1. Solicitation No. CSP 23-005 New Braunfels Fire Training Complex Site Infrastructure	2. Contract No.	3a. Addendum No. 1 3b. Modification No.	4. Effective Date of this Action 12/16/22
5. Name and Address of Offeror or Contractor	6. For Information Call: (No collect calls or Fax offers accepted) Purchasing: Barbara Coleman Phone No.: 830-221-4389 Fax No.: 830-608-2112		7. Amount of Contract/Order is: Increased by: Decreased by: New Total: <input type="checkbox"/> Unchanged

This Addendum No. 1 provides the minutes to the Pre-proposal Conference hosted on December 7, 2022 and answers to questions received by the question deadline of December 9, 2022.

ADDENDUM NO. 01

PROJECT: NEW BRAUNFELS FIRE TRAINING SITE INFRASTRUCTURE
LOCATION: NEW BRAUNFELS, TEXAS
PROJECT NO: 219065.00
DATE: DECEMBER 14, 2022

MEP1.0
MEP SITE PLAN

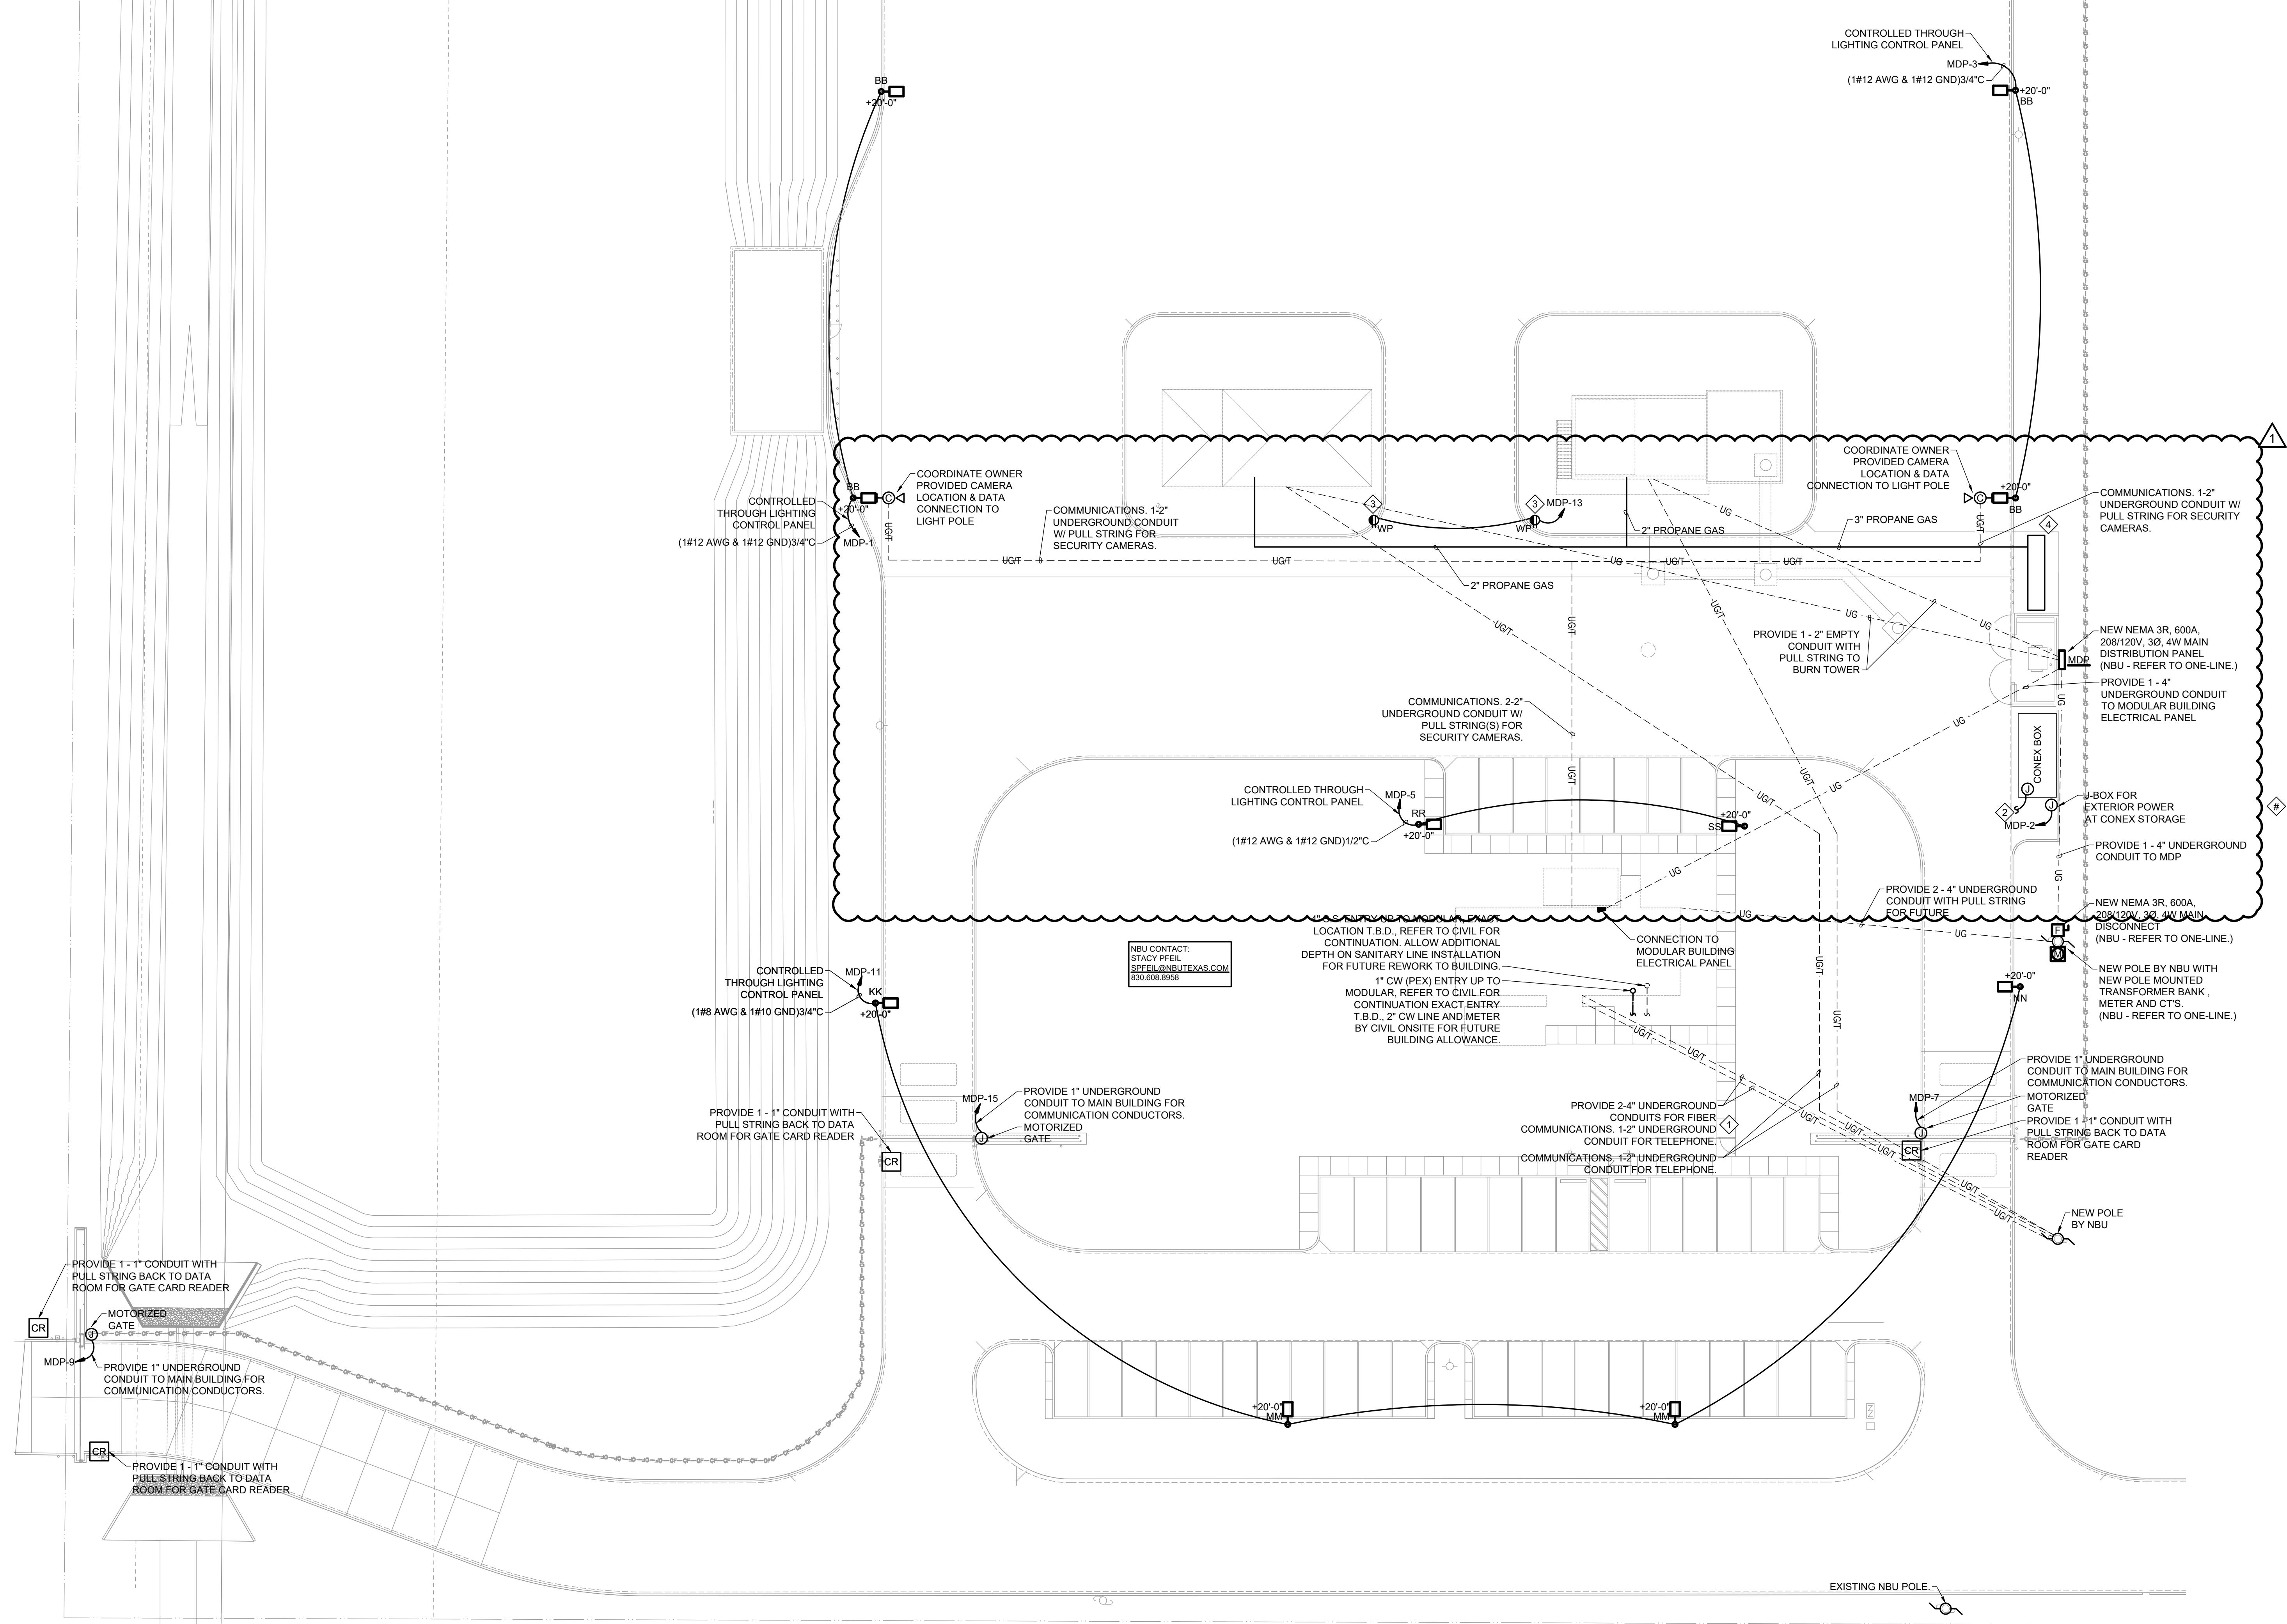
Item No. 7 (RE: Sheet MEP1.0) – MEP Site Plan

A. An underground communications conduit has been added to run from the modular building location and connecting the owner provided cameras to be mounted at the light poles on the east and west sides of the burn building locations.

MEP2.0

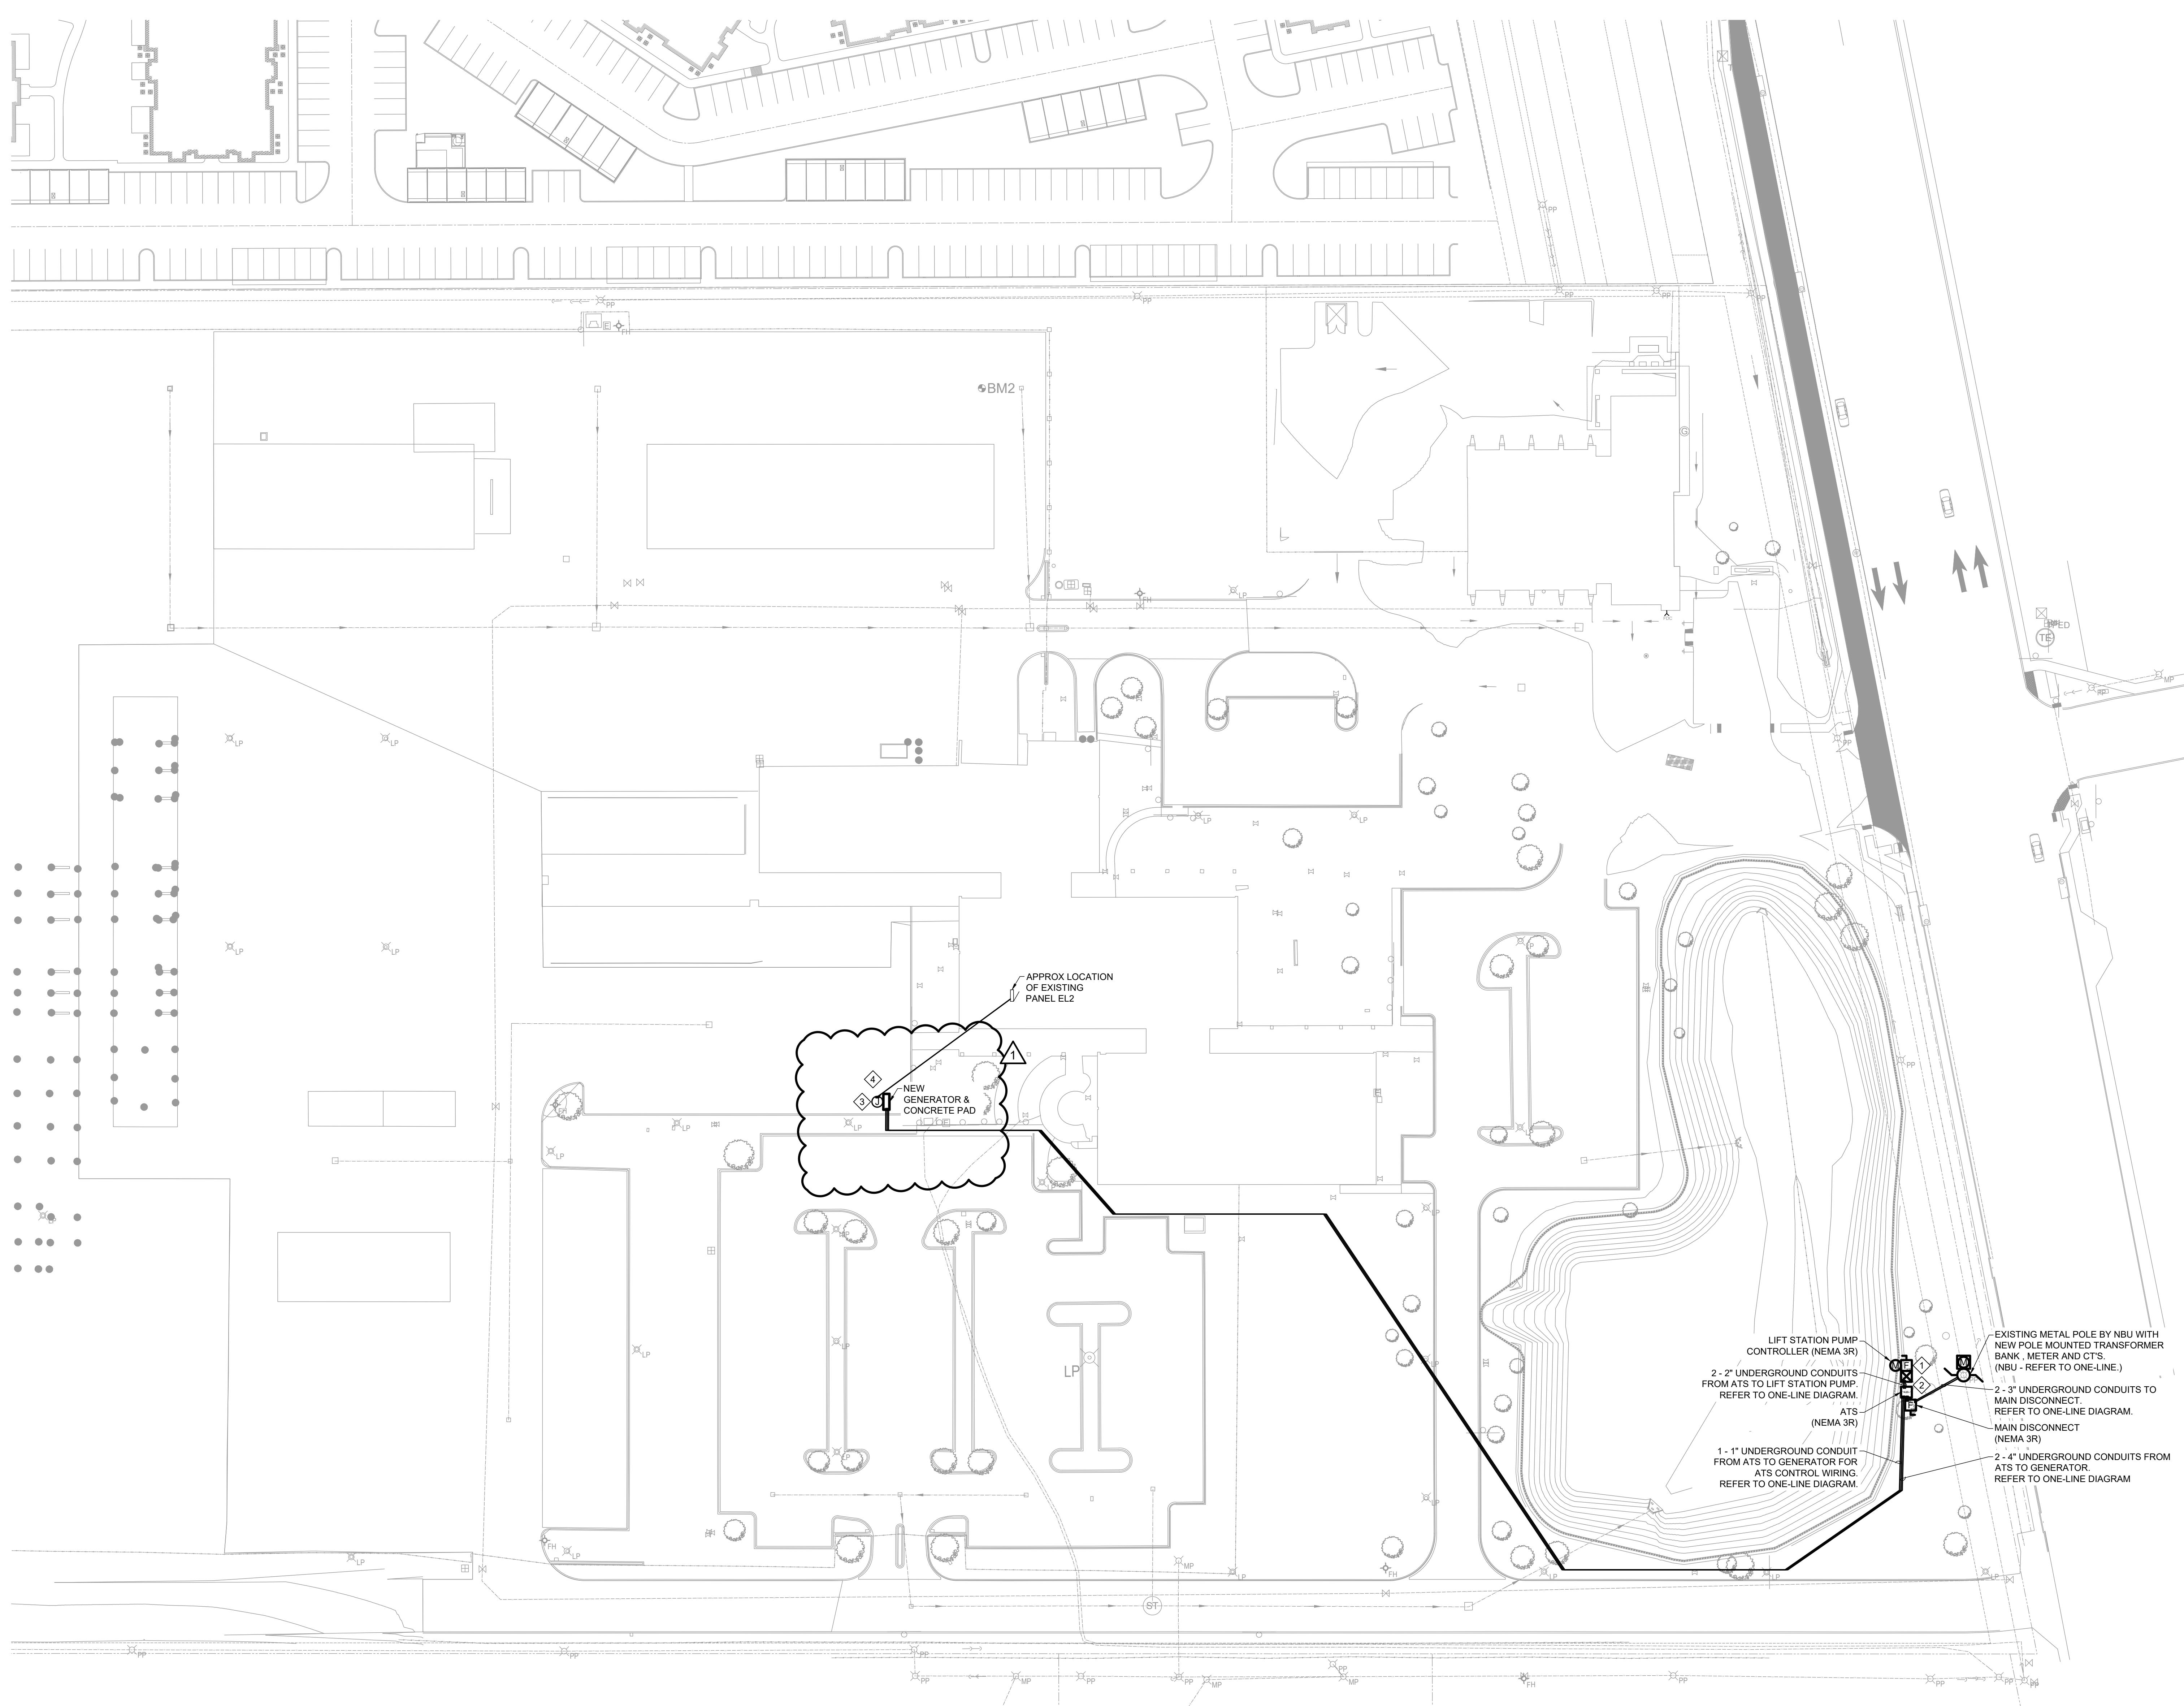
Item No. 8 (RE: Sheet MEP2.0) – MEP Site Plan – Lift Station

A. New Generator has been shifted over to the West of the existing generator for the NBU facility.

Item No. 9 The generator shown on sheet MEP2.0 is a new generator that will serve the lift station for the detention pond at the east end of the site. This generator does not replace or tie into the existing generator.
